Proposal for SPI-5 Programmable Termination

T10/01-270r0

Changes to section 7.3.1 LVD Terminations

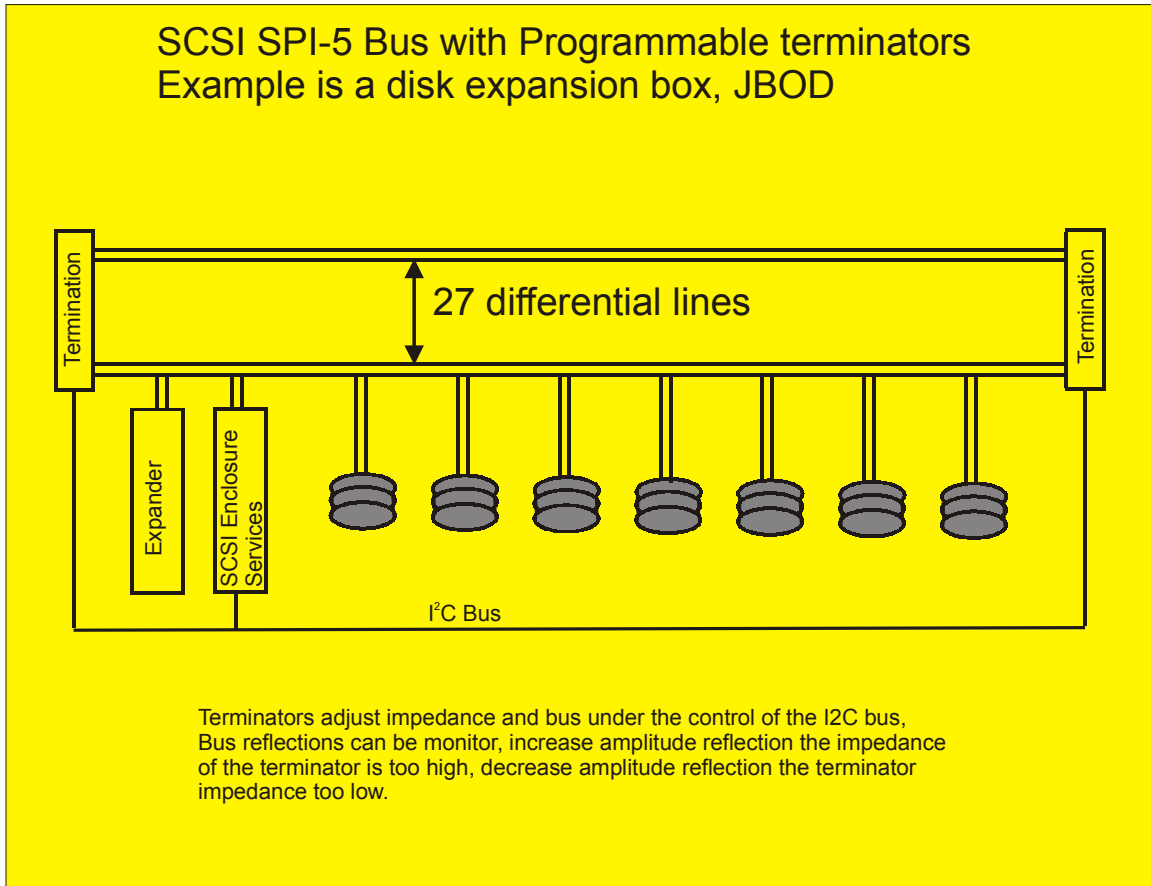
Add a paragraph below Table 20

Programmable terminators shall be adjustable in nominal 5 ohm monotonic steps from the nominal value of 105 ohms to a range between 55 and 130 ohms.

Bias current shall be adjustable in nominal 50 uA monotonic steps from 0.70 mA to 1.45 mA.
